AMENDMENT #2
June 5, 2024
Invitation for Bids (IFB) Number
PCCD-24-LPCW28Rehab-01, 5/16/24
Issued by
Plum Creek Conservation District
Lockhart, Texas

Amendment No. 2 (6-5-2024)
IFB PCCD-24-LPCW28Rehab-01 (Site 28 Rehabilitation)

PART V – DRAWING NO. TX-EN-0781

- Sketch showing Drawing Sheet 4 changes and new Note 5.

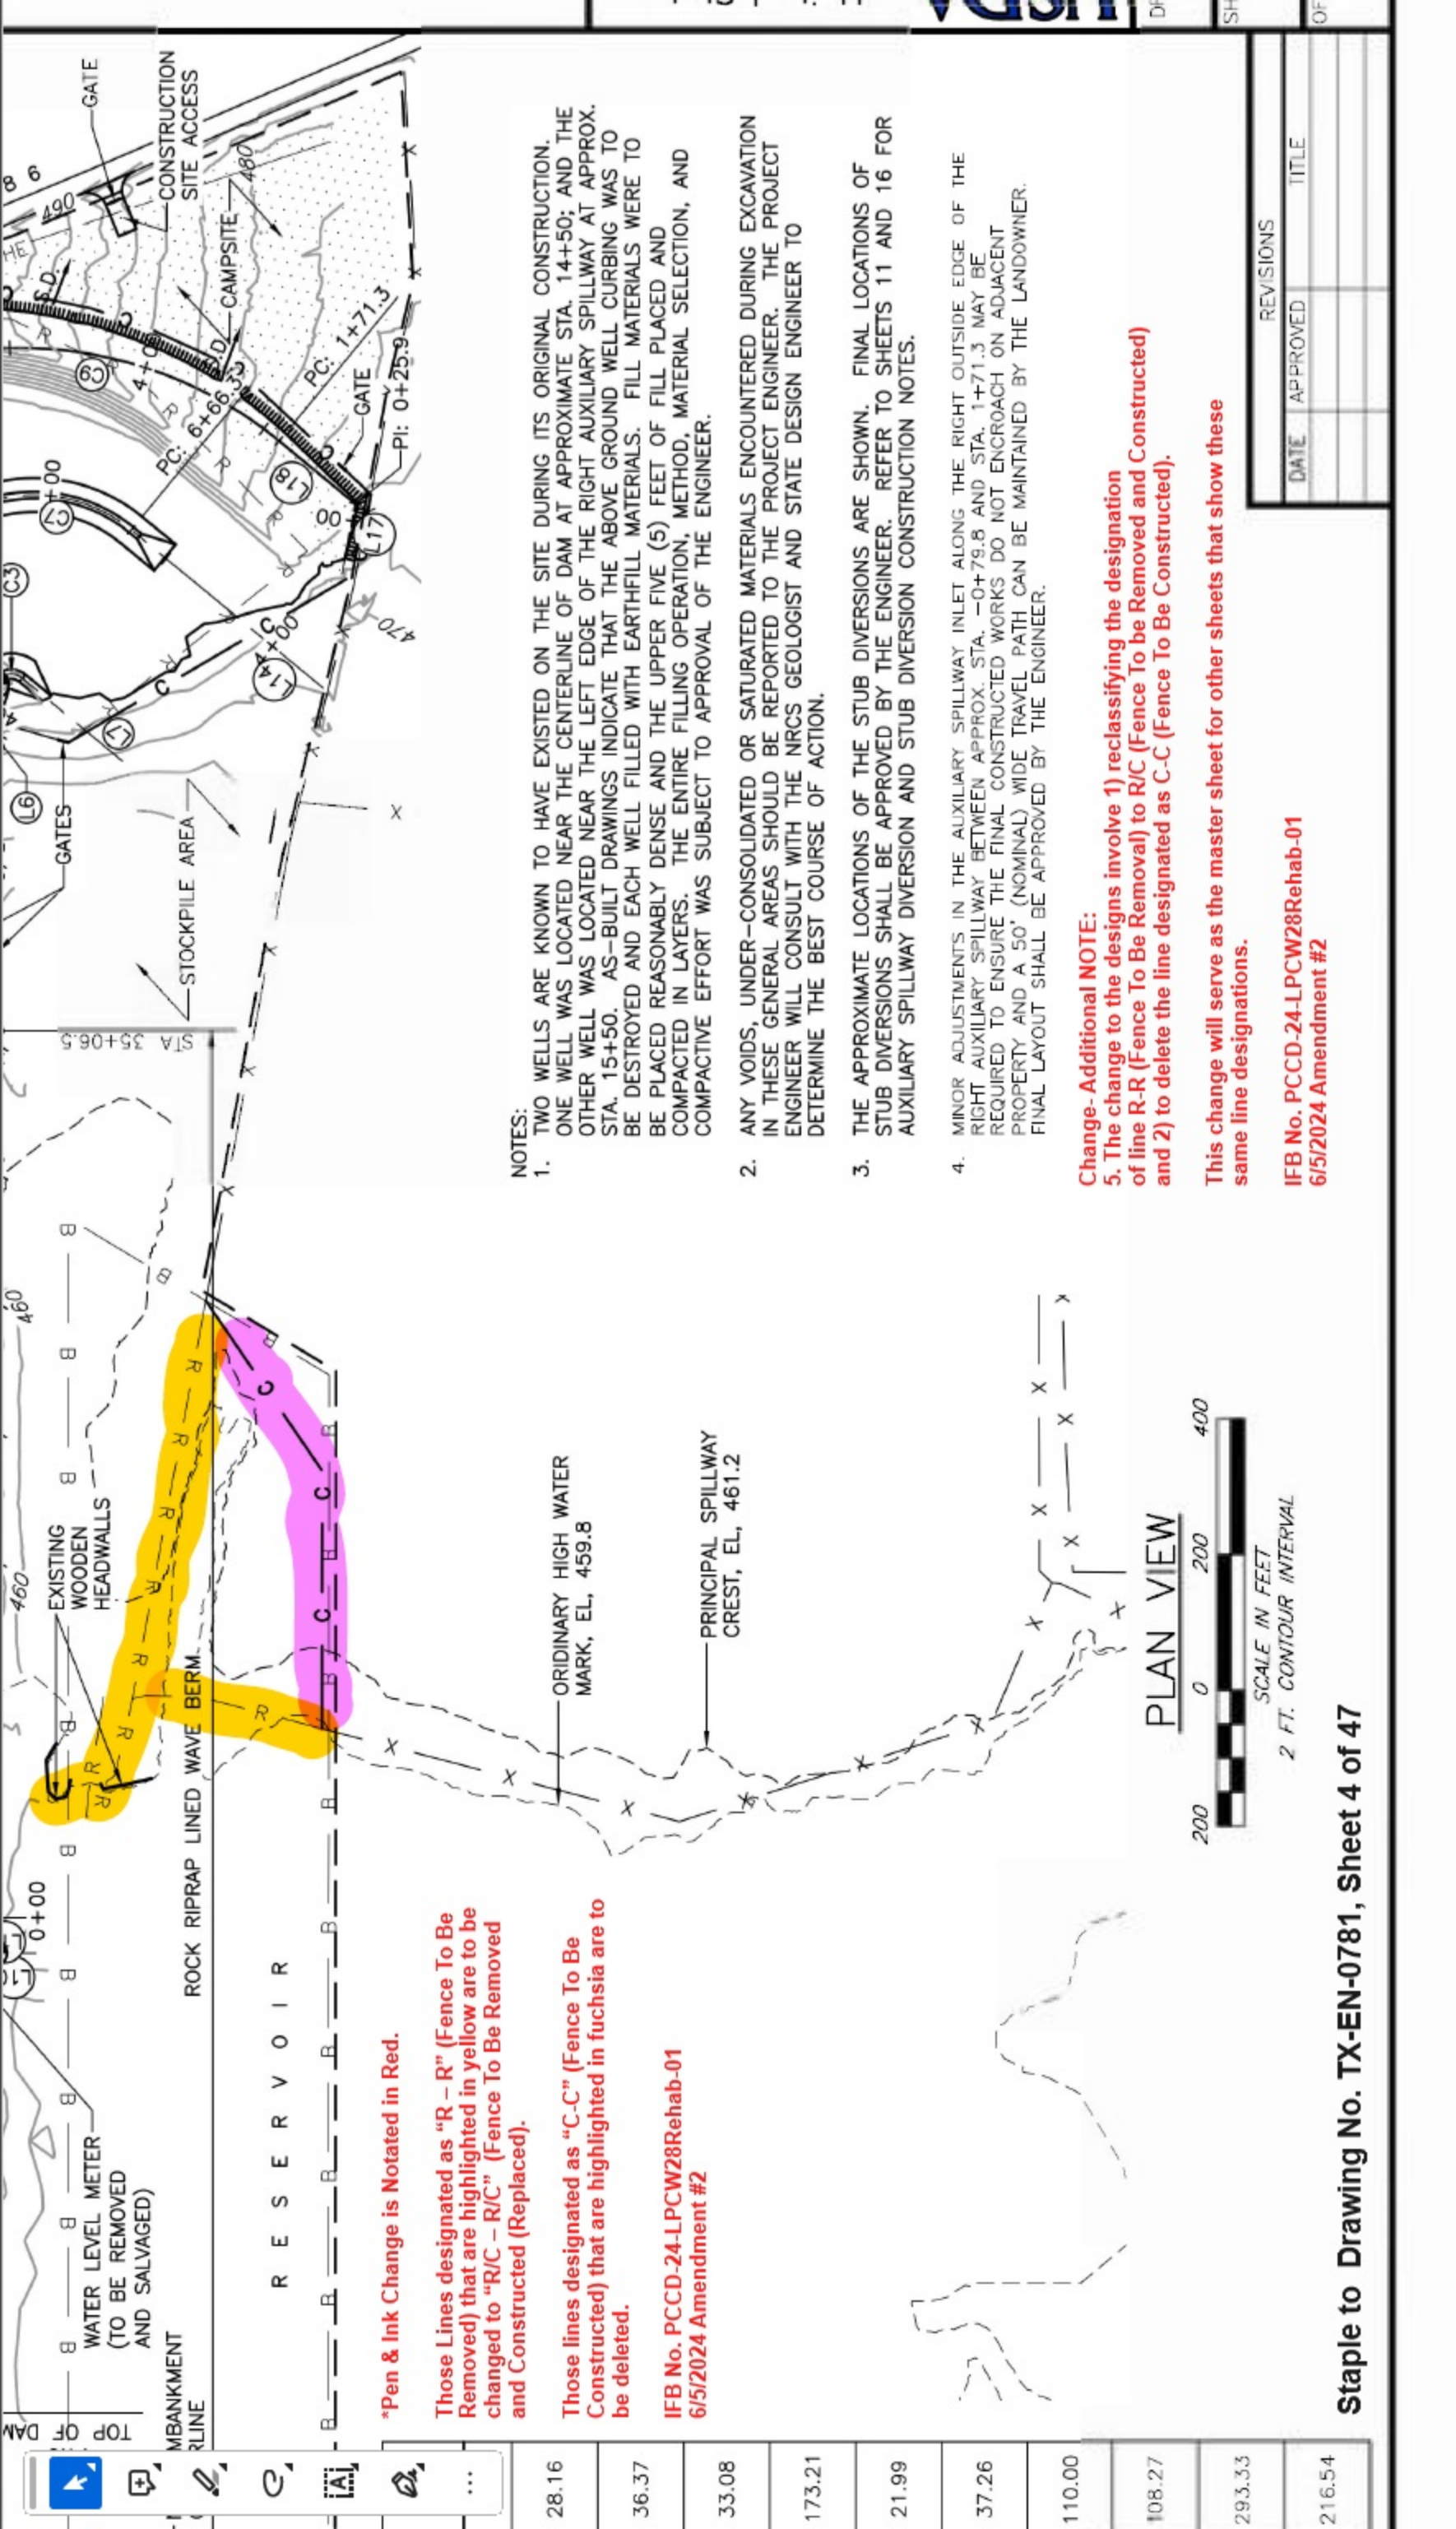
Sheet 4 – STAPLE the attached page to Sheet 4 – this specifies some changes to field fence and adds a new Note 5 to Sheet 4.

Those Lines designated as "R - R" (Fence To Be Removed) that are highlighted in yellow are to be changed to "R/C - R/C" (Fence To Be Removed and Constructed (Replaced)).

Those lines designated as "C-C" (Fence To Be Constructed) that are highlighted in fuchsia are to be deleted.

Change-Additional NOTE:
 5. The change to the designs involve 1) reclassifying the designation of line R-R (Fence To Be Removal) to R/C (Fence To Be Removed and Constructed) and 2) to delete the line designated as C-C (Fence To Be Constructed).

This change will serve as the master sheet for other sheets that show these same line designations.
